10-G-24-HZ
APPLICATION FOR CERTIFICATE OF APPROPRIATENESS

1800 Jefferson Ave. 37917
Edgewood-Park City H

Staff Report

File Number: 10-G-24-HZ

1 GROUND FLOOR PLAN
3/16" = 1'-0"

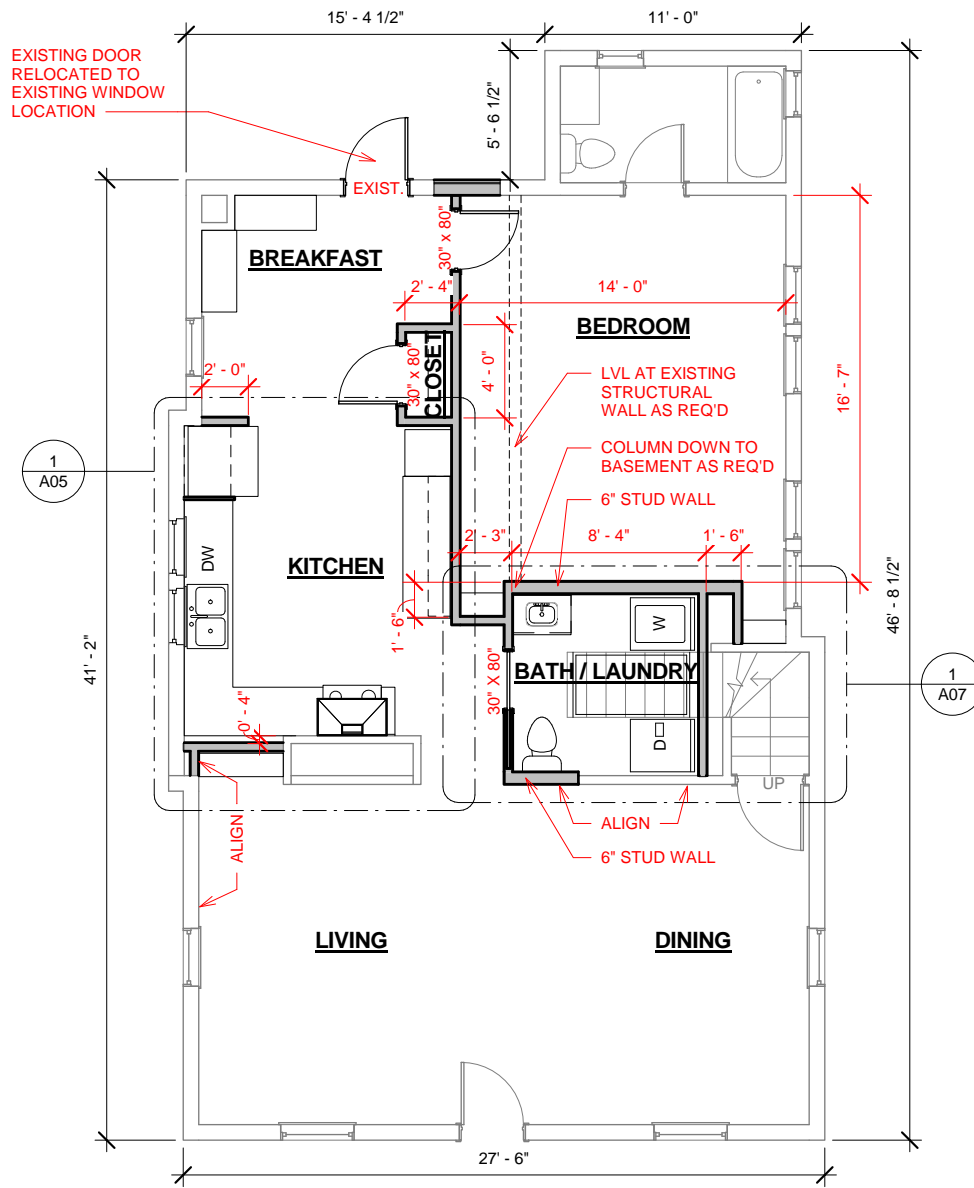
Rear elevation door to be shifted to location of adjacent window.

Window to be removed and replaced with existing rear door.

Existing rear aluminum window
